**APPENDIX- E**  
**THREE CELLS EXISTING SEWAGE LAGOONS**

**APPENDIX-F**  
**RESPONSE TO NWB SPREAD SHEETS**

**RESPONSE**  
**ON**  
**O&M MAUAL CONFORMITY**

Cape Dorset Operation and Maintenance Manual, Sewage Treatment System Conformity Assessment

Plan of old 3 Cells Lagoons- Municipality of Cape Dorset

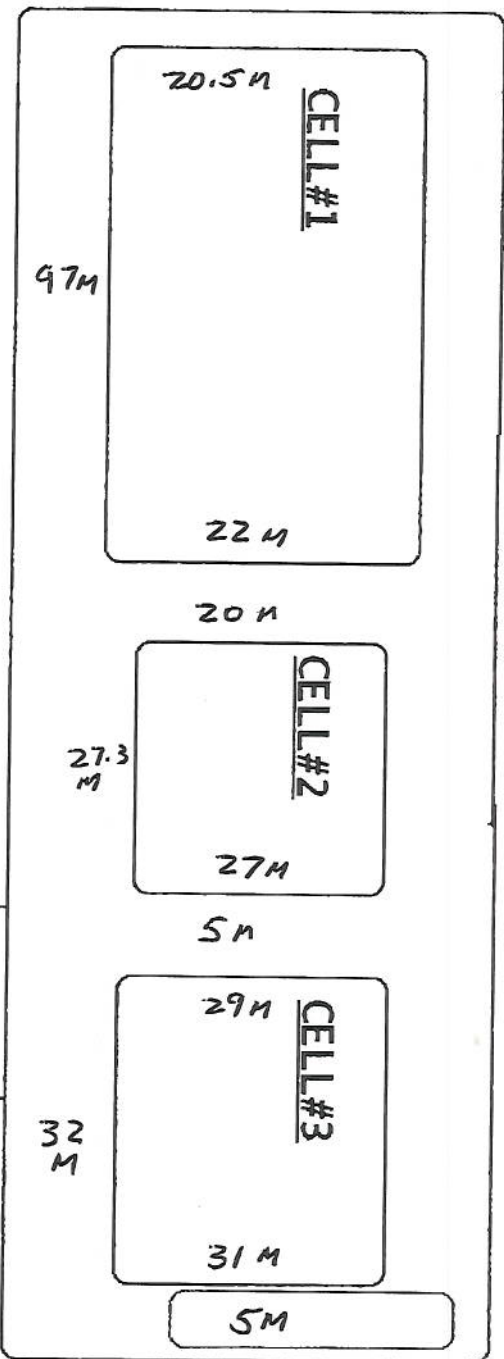
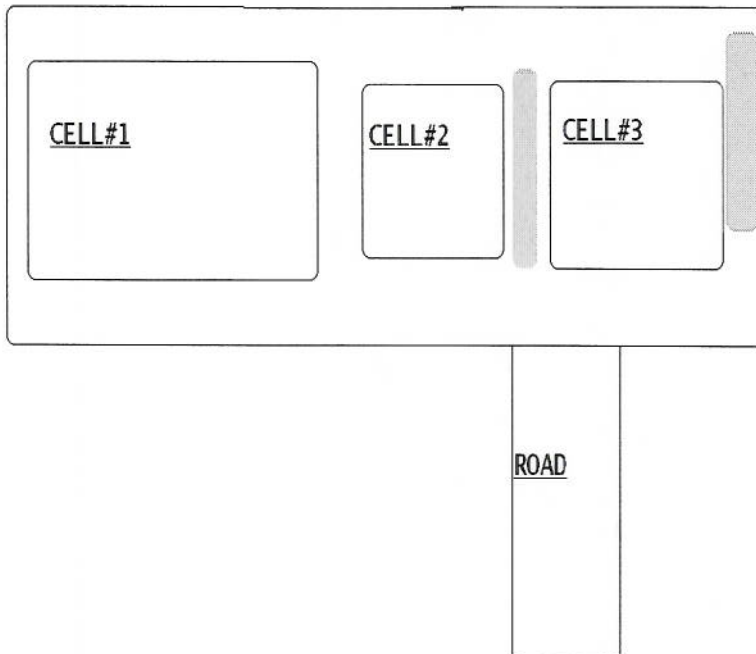
iv	Description of the details of any repairs, upgrades and maintenance required for the use of part or all of the 2001 Sewage Disposal Facility or Emergency Sewage Disposal Facility;	Not found. Work may not have been carried out. Clarification required.	Part G, Item 1 requires the Licensee submit to the Board, for approval in writing, within ninety (90) days of issuance of the License, a detailed Final Abandonment and Restoration Plan for the 2001 Sewage Disposal Facility and the Emergency Sewage Disposal Facility. The Plan should incorporate, where applicable, the appropriate sections as described in Part G, Item 2.	The existing three cells lagoon berms have been repaired to keep using until the new facility will be commissioned. During using the new facility, the old facility will be still kept active for any emergency backup. The photos attached in <b>Appendix -E</b> shows the location of these cells and repair works done on the berms.

SECTION OF BERM BETWEEN CELL 2 & 3 REPAIRED, SECTION OF BERM AT END OF CELL 3 RAISED 2 FEET TO FIX YEARLY EROSION.

5 LOADS OF GRAVEL USED IN REPAIRS.  
APPROX. 60 CUBIC METERS
